BULLETIN NUMBER:
SB13-04-S001A

SAFETY RECALL 12V-406

DRIVER DOOR SWITCH SHORT CIRCUIT

- 2006-2007MY Isuzu Ascender Vehicles

Figure 1 – Driver Side Door Lock & Side Window Switch

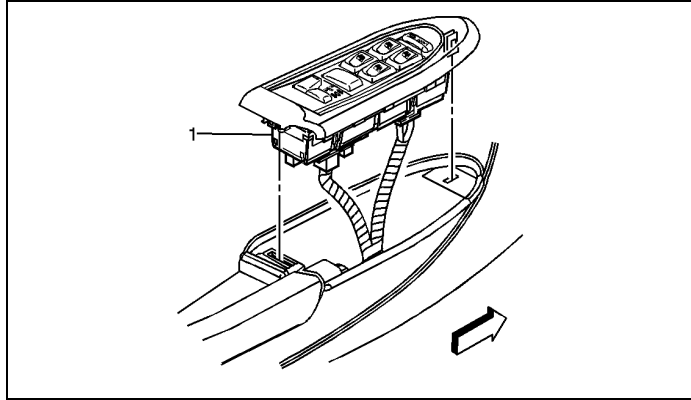
If fluid enters the driver's door module, it may cause corrosion that could result in a short in the circuit board. A short may cause the power door lock and power window switches to function intermittently or become inoperative. In rare cases, a short may cause overheating, which could melt components of the door module, producing odor, smoke, or a fire.

Service Facilities are to inspect the part number of the door module and, if necessary, install a new door module.

1. Remove the driver side door lock and side window switch. Refer to *Door Lock and Side Window Switch Replacement - Driver Side* in the service manual.

2. Determine the part number on the driver side door lock and side window switch. The part number is on the side of the switch on the label.
 - a) If the part number on the switch is listed in the parts table, no repair is required. Re-install the driver side door lock and side window switch. Refer to *Door Lock and Side Window Switch Replacement – Driver Side* in the service manual, and then proceed to Step 3, “Applying the Campaign Label”.

- b) If the part number on the switch is NOT listed on the table above, replace the driver side door lock and side window switch. Refer to *Door Lock and Side Window Switch Replacement – Driver Side* in the service manual.
